# ADDENDUM

Date:	March 9, 2020
Project:	Mountainstar- Ogden Regional Medical Center <b>Psych Exam Remodel</b> 5475 South 500 East Ogden, Utah 84405
Addendum Number:	<b>1</b>

**PROJECT:** ORMC Psych Exam Remodel

**RE:** Addendum #1

**2 PSYCH EXAM PLUMBING PLAN**  
SCALE: 1/4" = 1'-0"

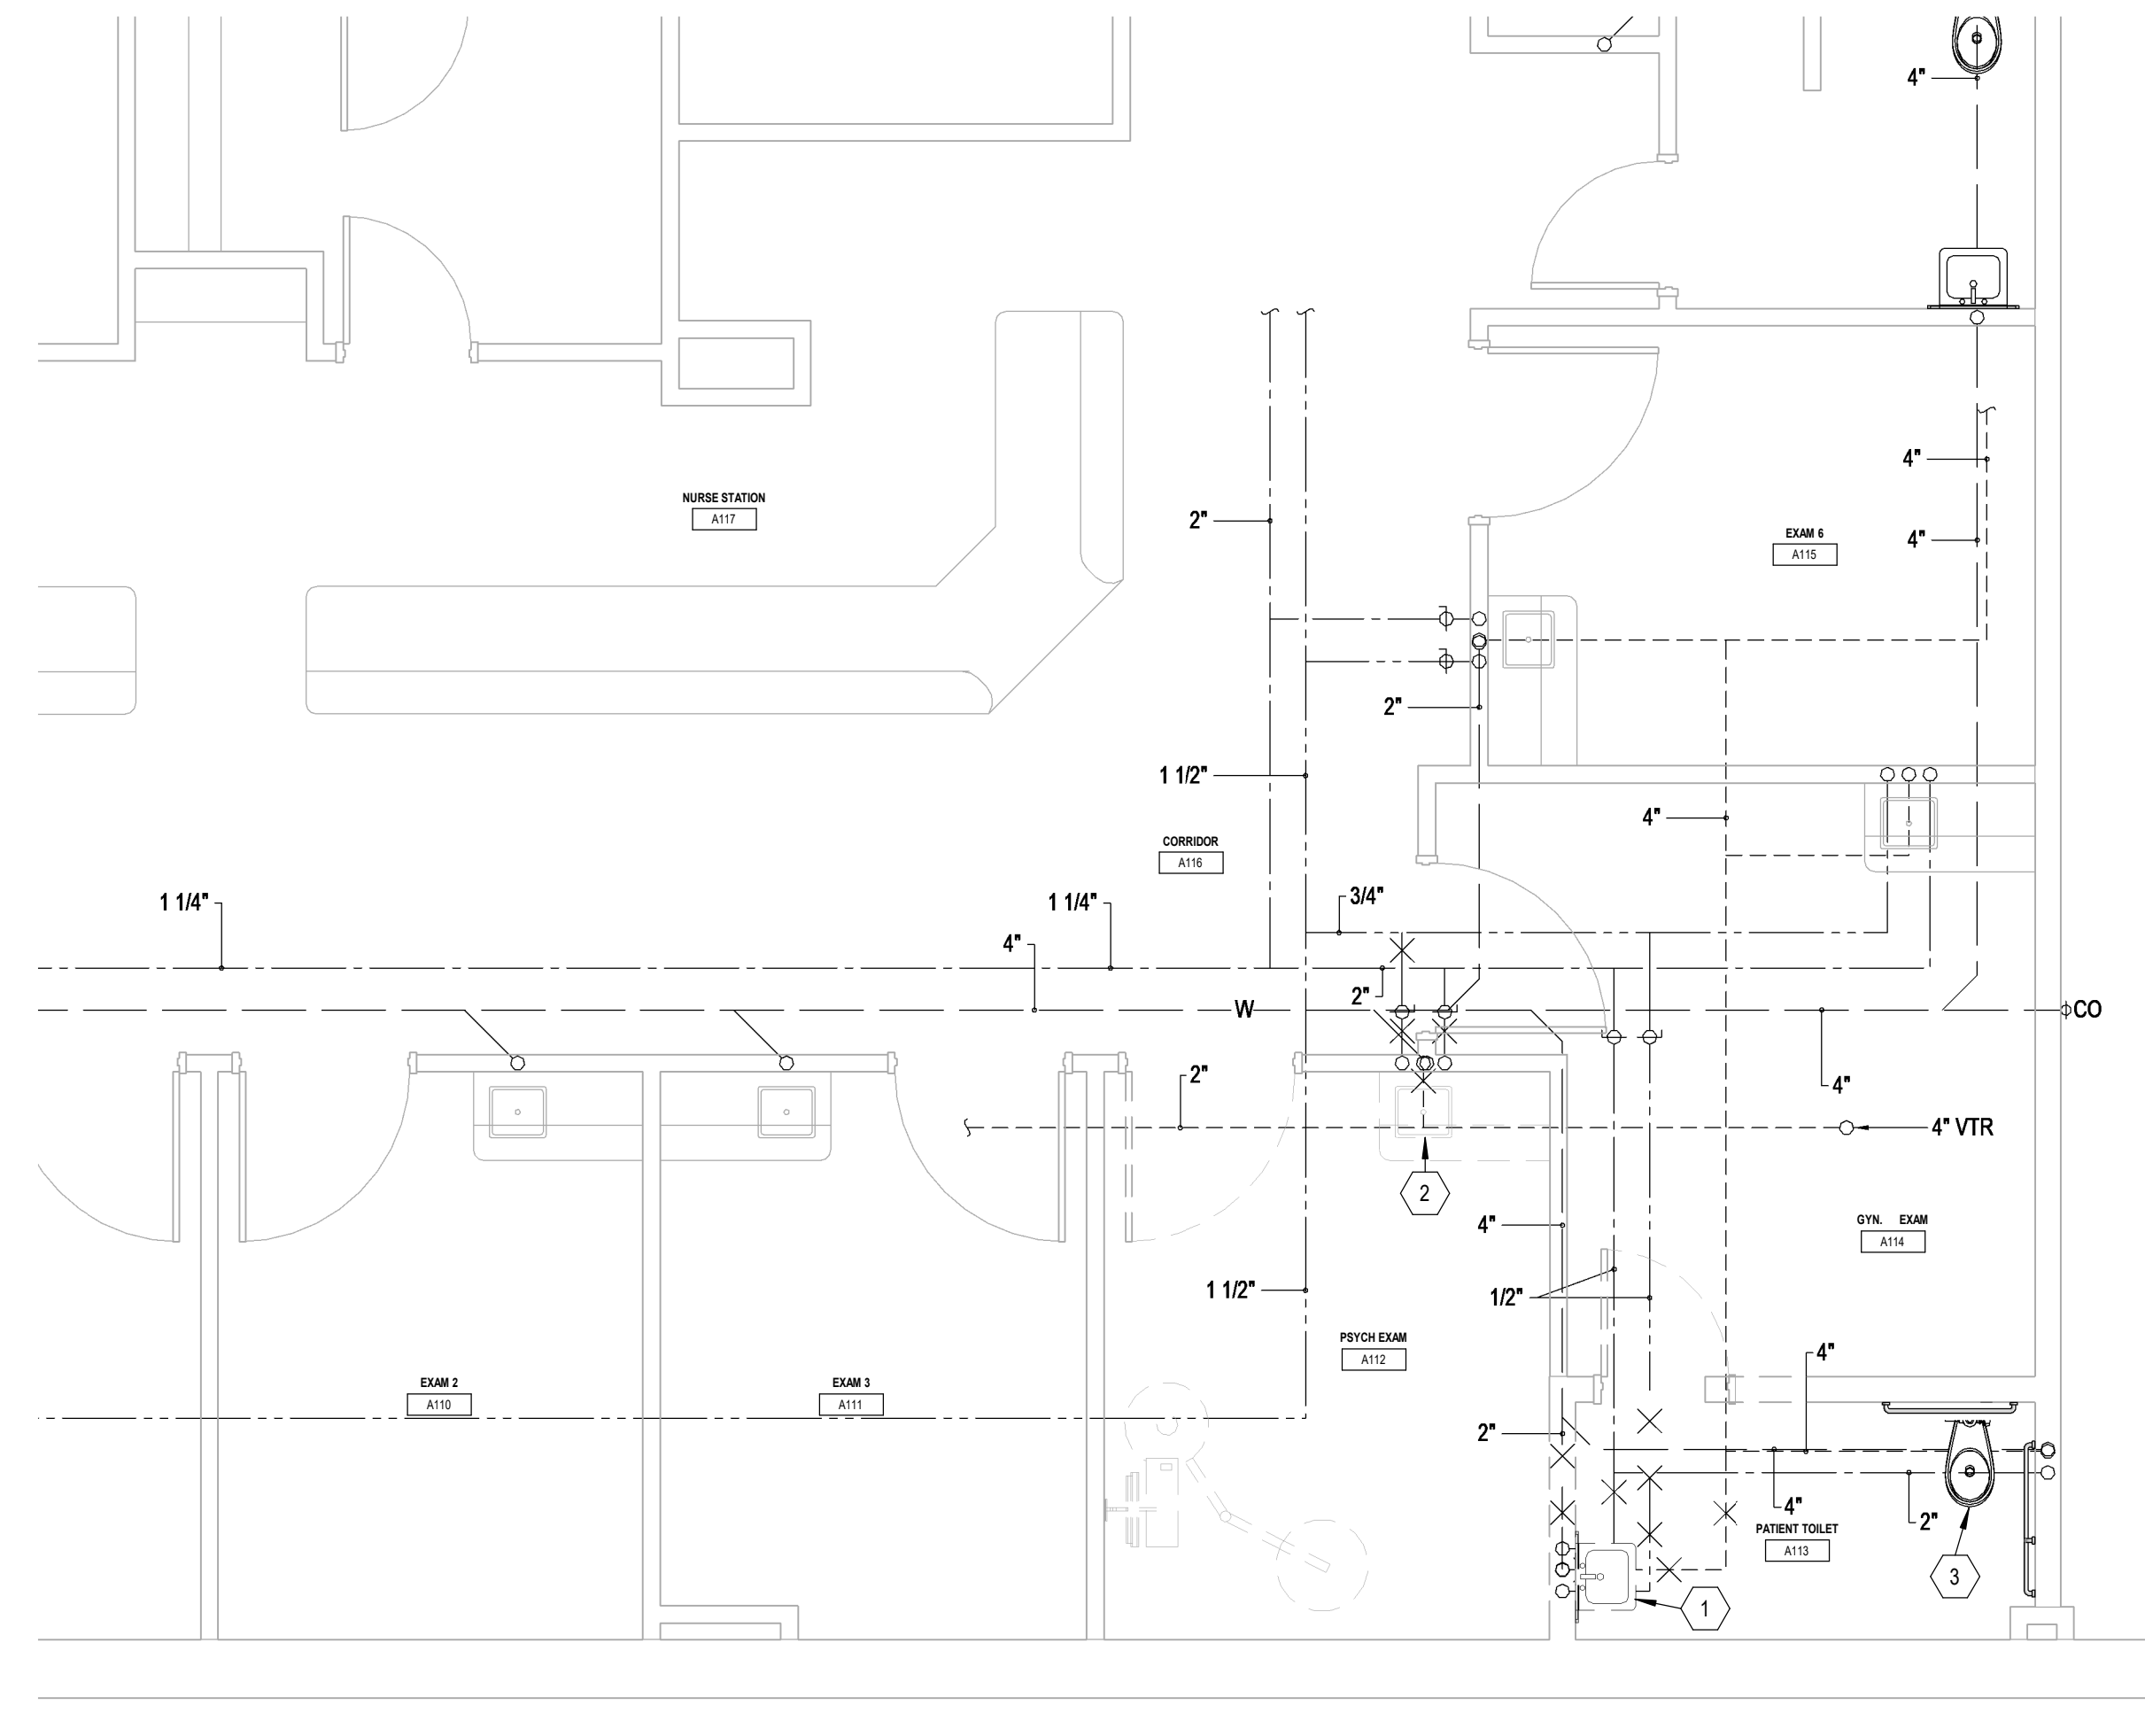
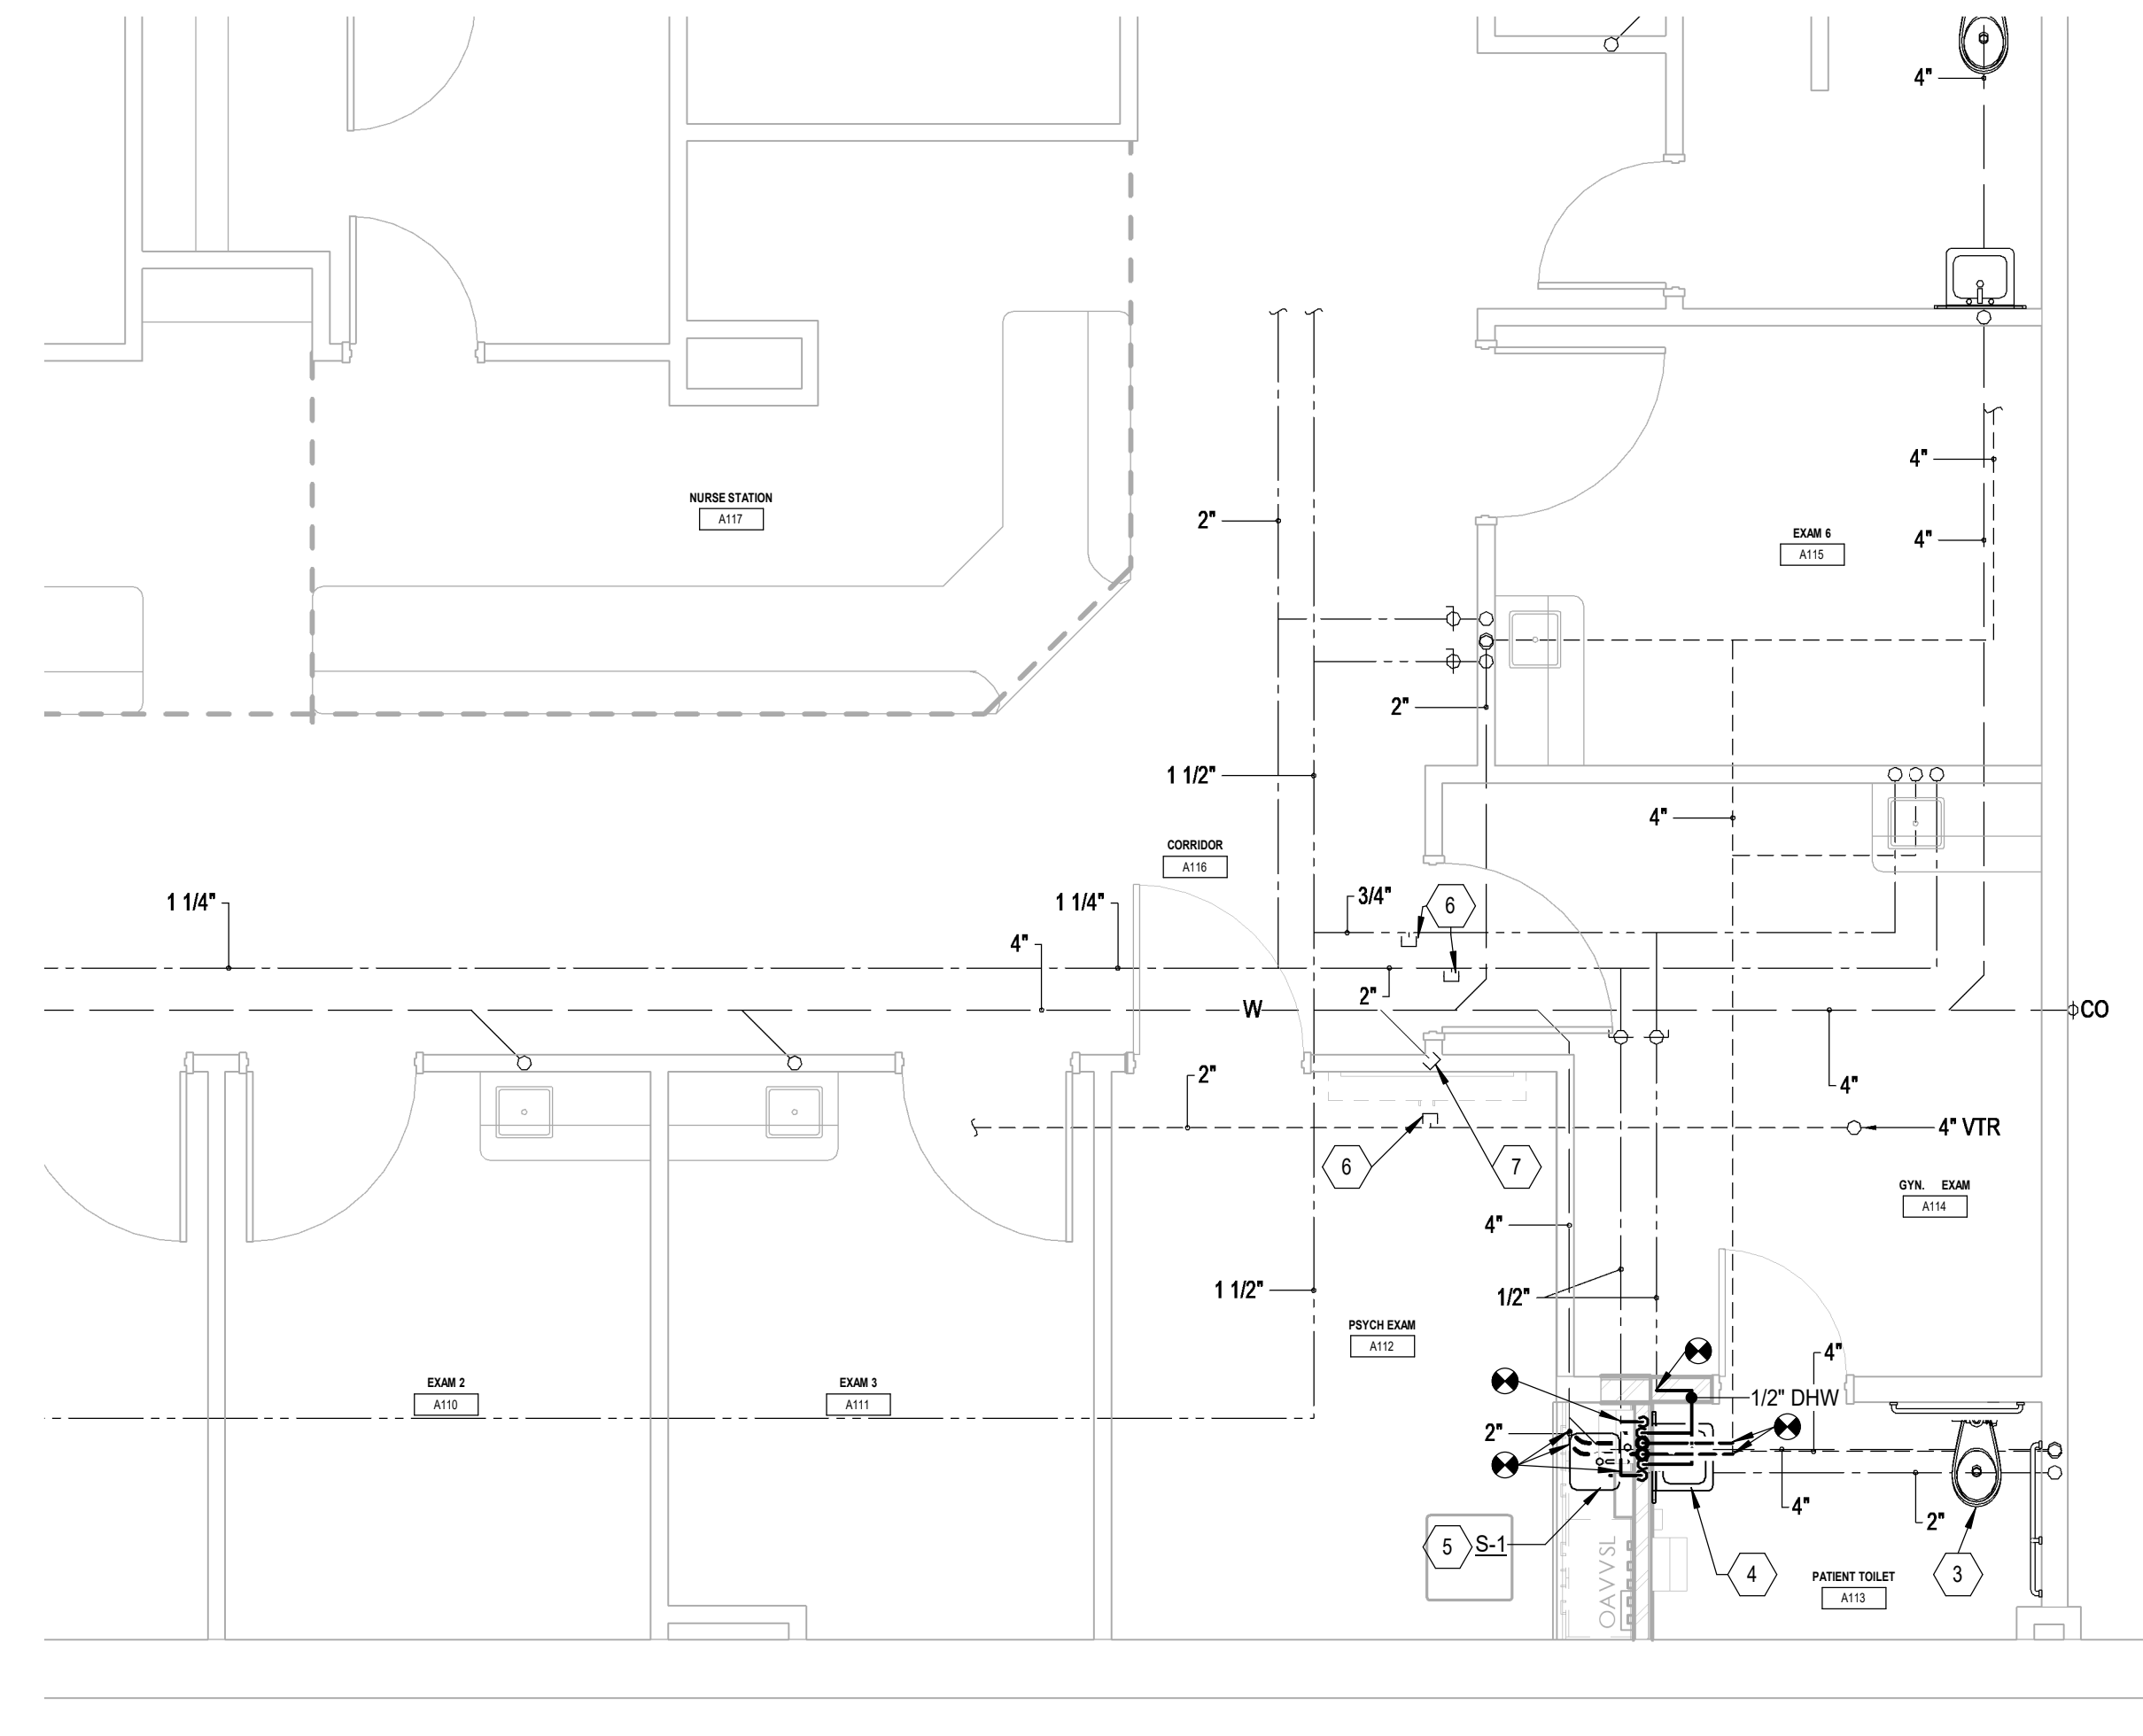
- a. Grilles, Registers, and Diffusers
    - i. Diffuser CD-2 has been added to this schedule.
4. Sheet PP102 – Psych Exam Plumbing Plans
  - a. Keyed notes #1, 4, & 7 have been updated to call for core drilling in lieu of saw cutting to install the new waste piping. These notes now also explain that the waste piping work will need to be done in the ceiling of the floor below.

1. THIS EXISTING LAVATORY IS TO BE REMOVED AND REINSTALLED IN A NEW LOCATION IN PATIENT TOILET A113. PROTECT FROM DAMAGE. DEMOLISH THE ASSOCIATED SUPPLY, DRAIN, & VENT PIPING BACK TO THE APPROXIMATE LOCATIONS SHOWN. CORE DRILL THE FLOOR AS REQUIRED TO EXTEND THE DRAIN PIPING OVER TO THE SINK'S NEW LOCATION IN PATIENT TOILET A113. FIELD VERIFY THE EXTENT OF WORK.

3. THIS EXISTING WATER CLOSET IS TO REMAIN IN SERVICE. PROTECT FROM DAMAGE.
4. REINSTALL THE SALVAGED LAVATORY IN THIS LOCATION. CONNECT THE SUPPLY, DRAIN, AND VENT PIPING BACK INTO THEIR RESPECTIVE EXISTING MAINS. CORE DRILL THE FLOOR AS REQUIRED TO EXTEND THE DRAIN PIPING OVER TO THE SINK'S NEW LOCATION. THE WASTE PIPING WORK WILL NEED TO OCCUR IN THE CEILING OF THE FLOOR BELOW. CAREFULLY COORDINATE WHEN TO REMOVE THE CEILING OF THE FLOOR BELOW TO COMPLETE THIS WORK. PATCH AND REPAIR THE FLOOR TO MATCH THE SURROUNDING FLOOR. FIELD VERIFY THE EXTENT OF WORK.

7. CAP THE EXISTING DRAIN PIPING BELOW THE FLOOR IN THIS LOCATION. PATCH AND REPAIR THE FLOOR AND WALL TO MATCH THE SURROUNDING FLOOR AND WALL. THIS WORK WILL NEED TO OCCUR IN THE CEILING OF THE FLOOR BELOW. CAREFULLY COORDINATE WHEN TO REMOVE THE CEILING OF THE FLOOR BELOW TO COMPLETE THIS WORK. FIELD VERIFY THE EXTENT OF WORK.

**3 LEVEL 1 POWER PLAN**  
SCALE: 1/4" = 1'-0"

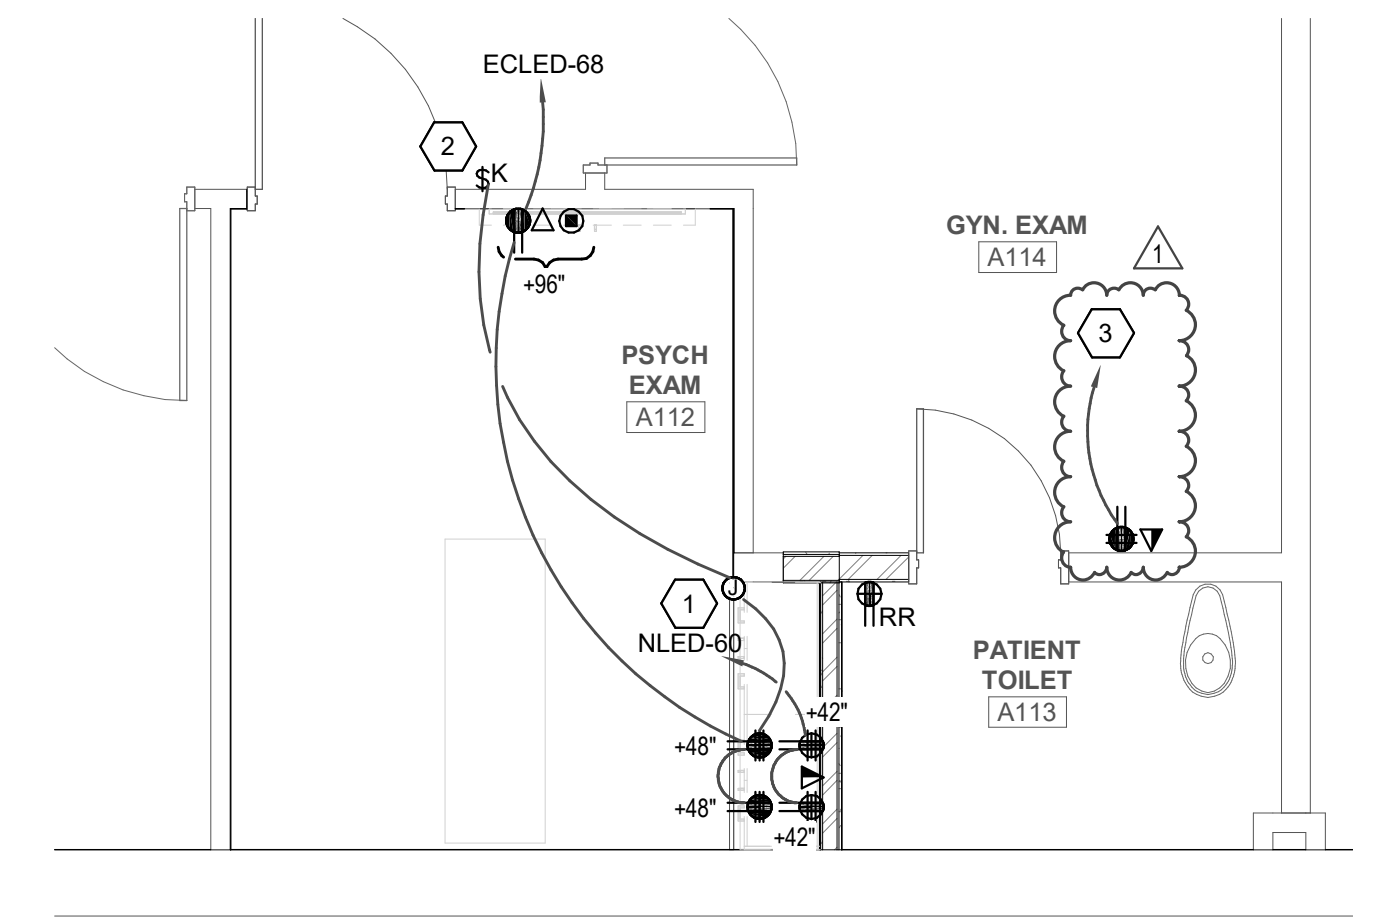
#### EP101 (See attached sheet)

1. Moved the power and data for computer to the South wall.
